ADDENDUM NO. 6

Project Name Q-Kids Childcare Project

Date Issued July 22, 2022

ELECTRICAL ADDENDUM #01

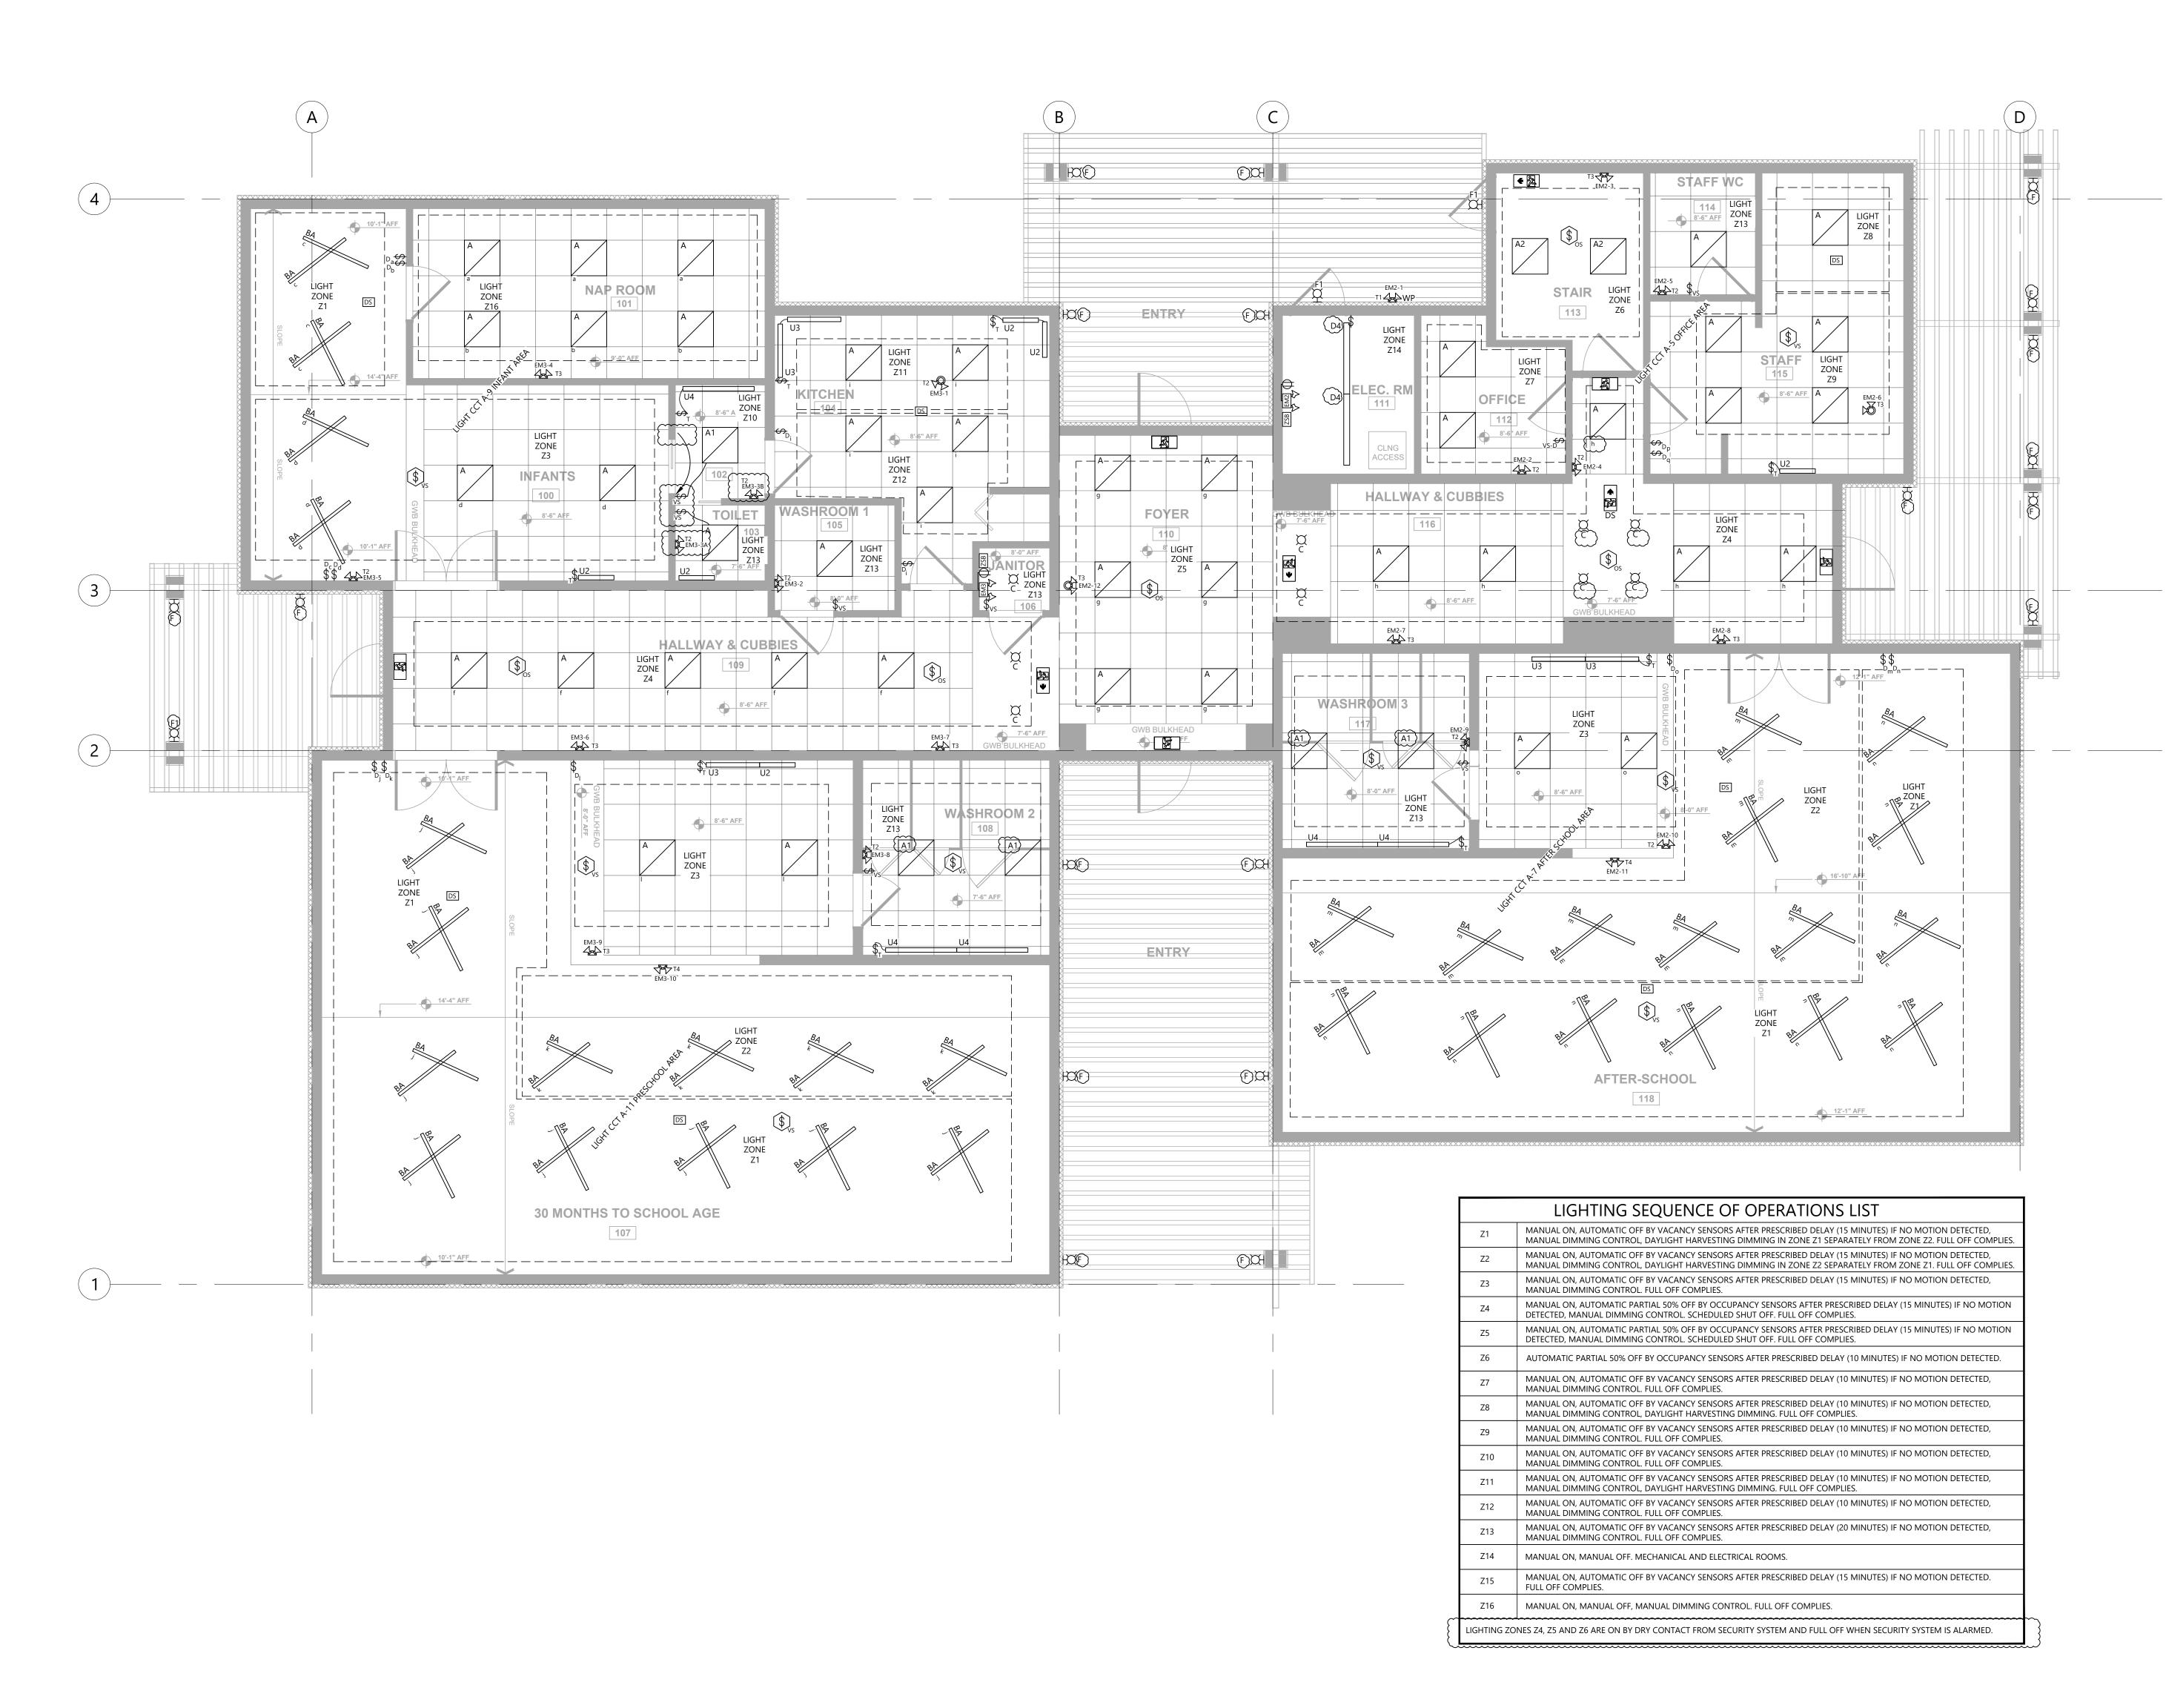
- 2. Q: Horn/strobe should be WP type?
 - A: Yes, refer to updated attached Drawing E2.0.
- 3. Q: Pull station missing from electrical room.
 - A: Yes, refer to updated attached Drawing E2.0.
- 4. Q: Kitchen device should be a fixed temp 196 HEAT, not a CO with sounder.
 - A: No, combined fixed heat and CO detectors with sounder base is requited. The symbol of fixed temperature detector with CO detector shown in the sounder base.
- 5. Q: 2 Control module missing from exits (door control).
 - A: Refer to Drawing E4.0.
- 6. Q: FACP location Riser indicates electrical room not indicated on floor plans.
 - A: Refer to Drawing E0.2, Drawing E0.3, Drawing E2.4.
- 7. Q: Recommend strobe device in preschool area after school area infants.
 - A: Not required.
- 8. Q: Horns should be horn/strobe type in Foyer 110 and in Staff 115.
 - A: No, horns only.

E3.0

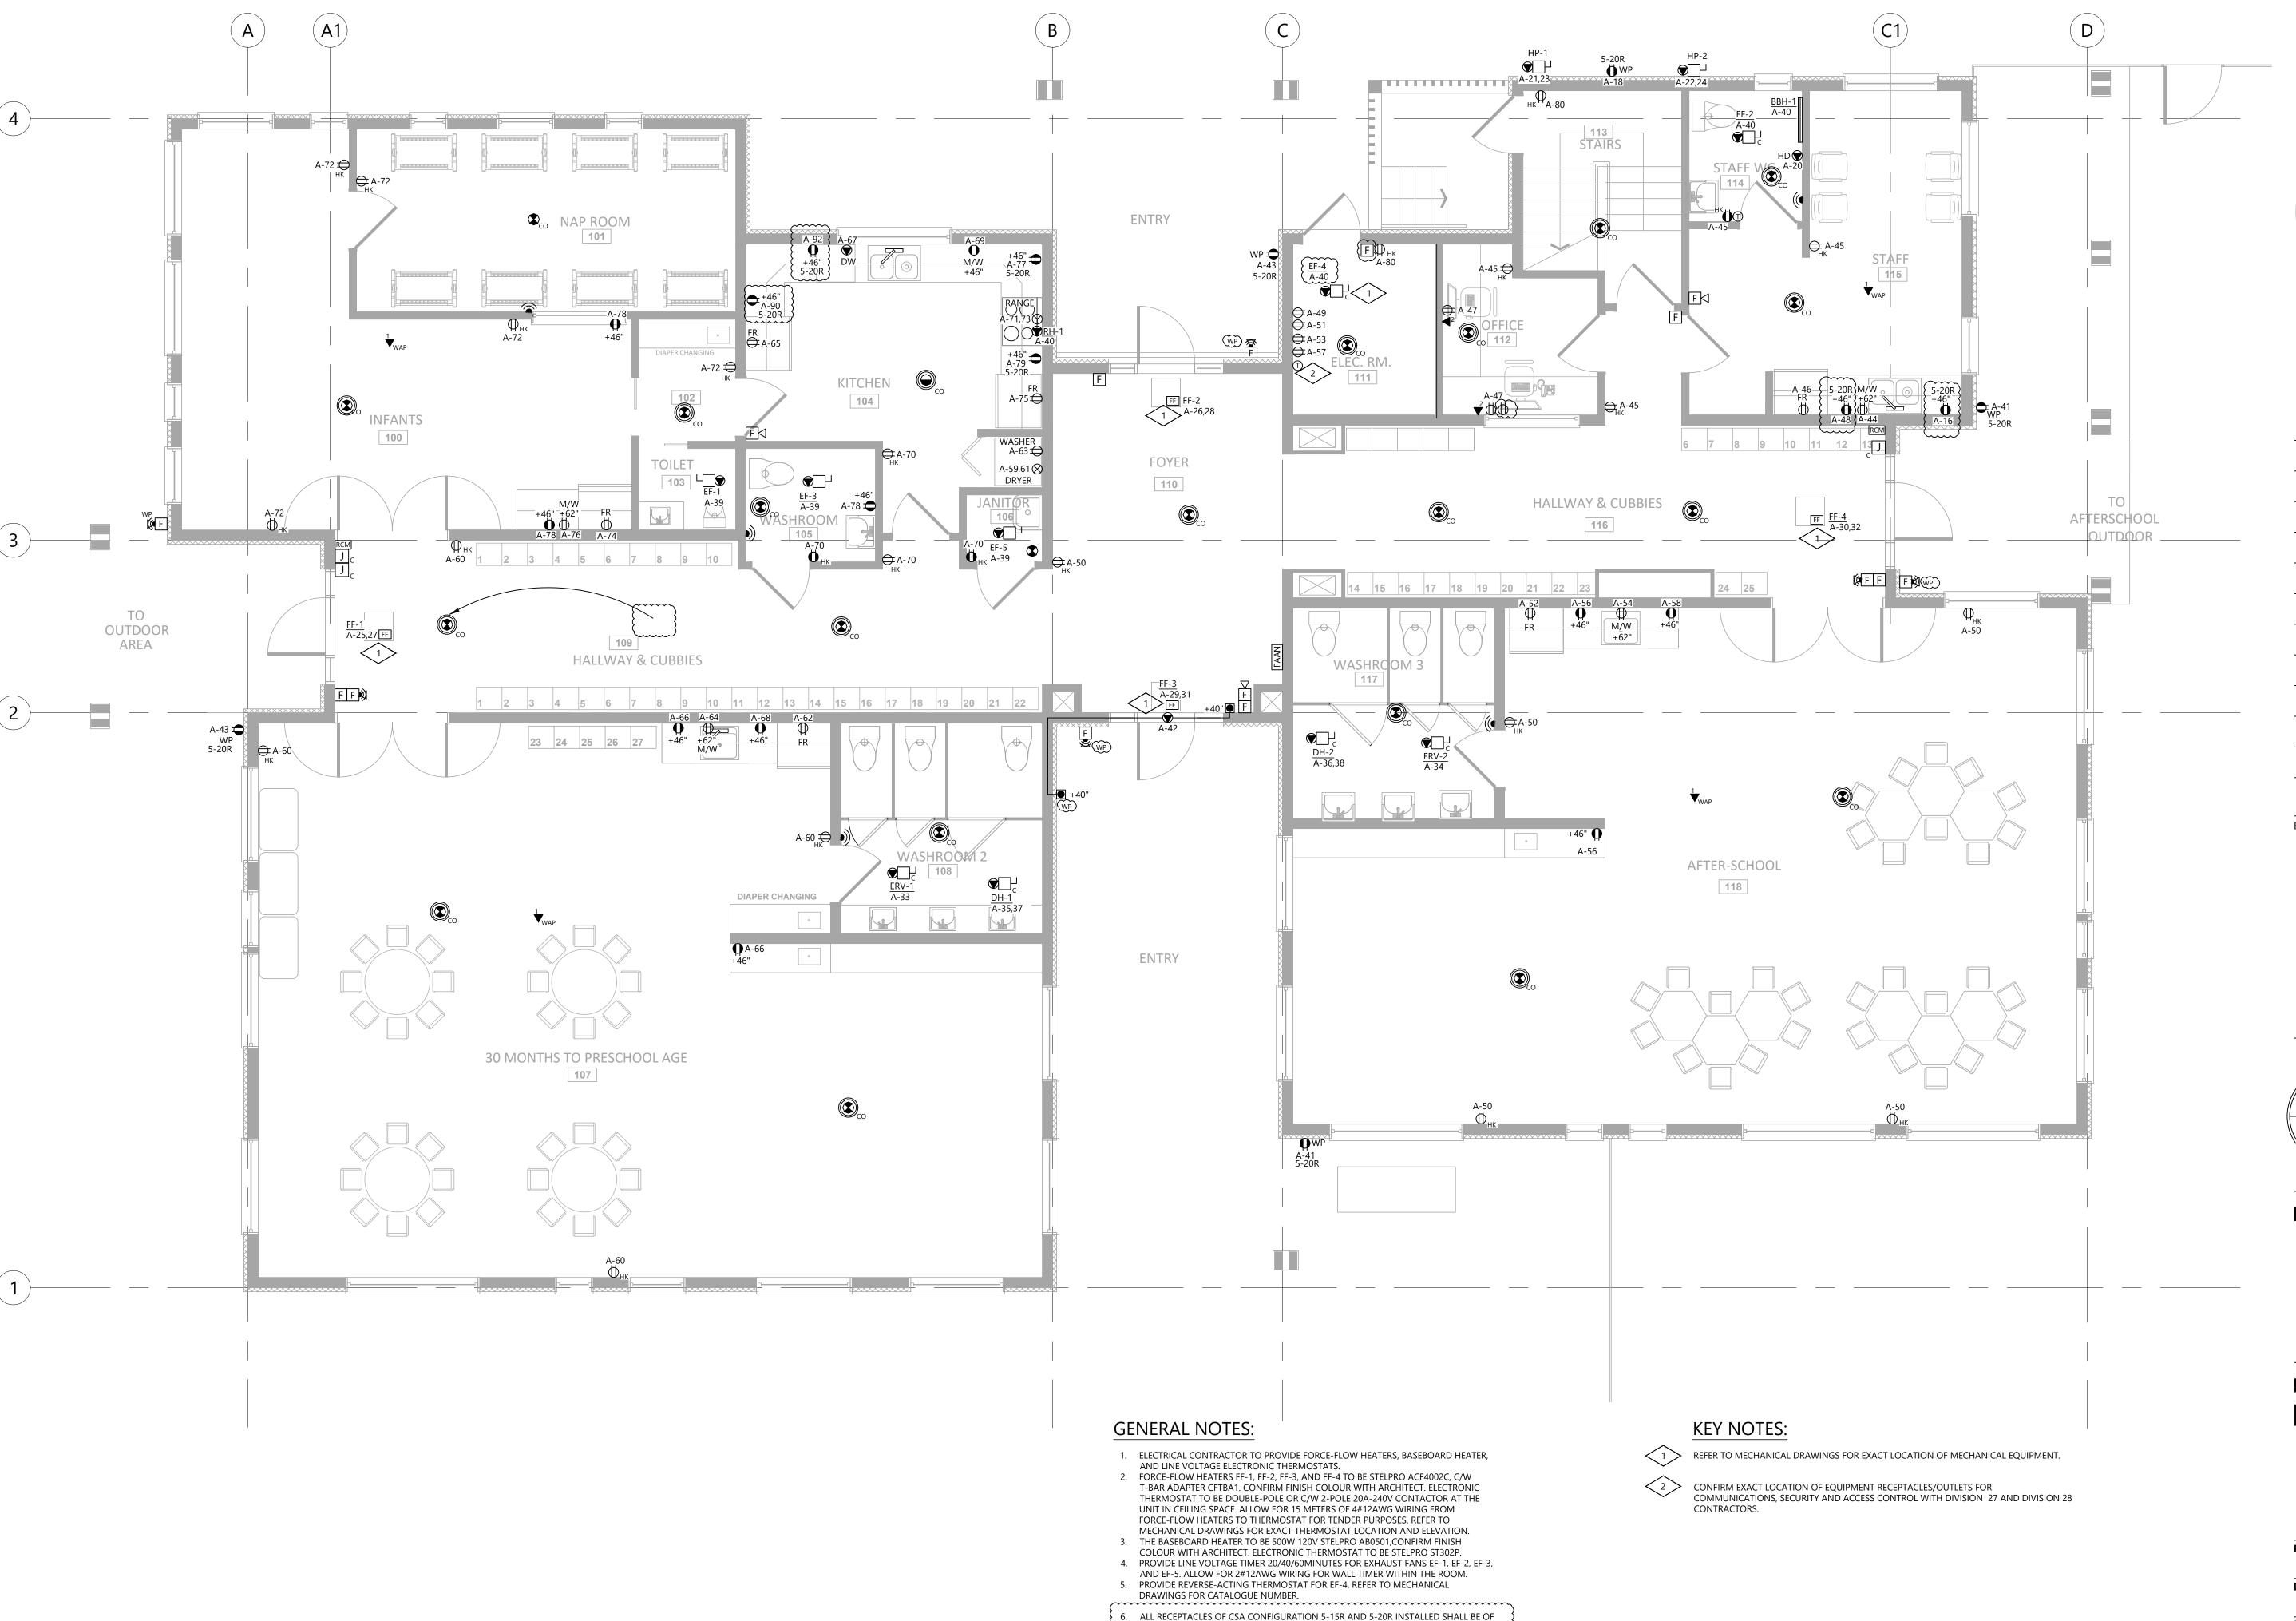
- 10. Relocate combined smoke/CO detector with sounder base as shown.
- 11. Add circuits A-16 in Staff 115 and A-90, A-92 in Kitchen 104.
- 12. Exterior pushbutton for the door operator to be weather proof.

- 13. Add second duplex receptacle in Office 112 for Video intercom as shown.
- 14. Add General Note 6. Refer to Drawing E2.0.
- 15. Relocate lighting control and EM remote head in Room 102 as shown.

- 16. Add lighting control and EM remote head in Toilet 103 as shown.
- 17. Washroom 2 108 and Washroom 3 117 luminaires to be Type A1 as shown.
- 18. Outdoor scones to be Type F. Refer to attached updated Drawing E3.0.

PROPOSED BC HYDRO OVERHEAD MAST LAYOUT SCALE: 1/4"=1'-0"

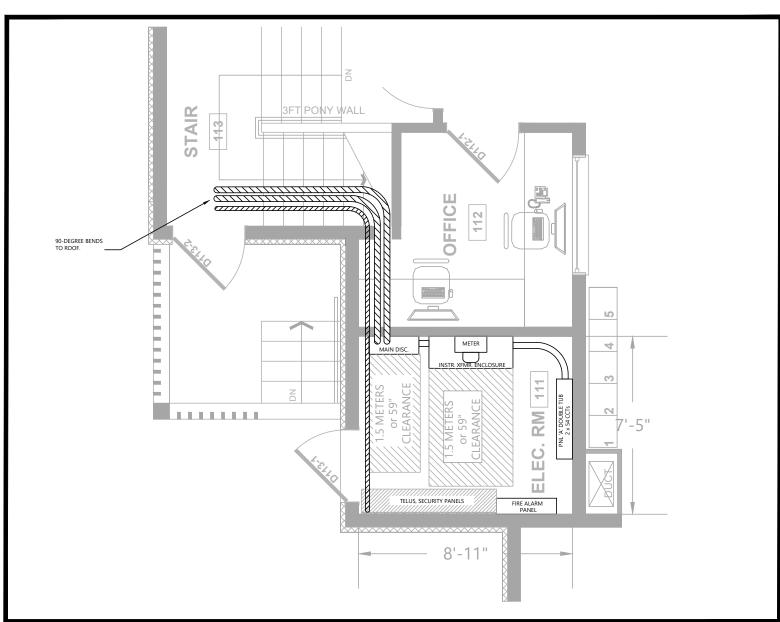
3.0 Refer to Electrical E0.1, Architectural A2.02: Service Entrance Conductors: Can these be moved to outside walls of stairwell behind Electrical Room?

The wood trellis above exterior stair does not allow installation of service musts as per BC Hydro and CEC requirements.
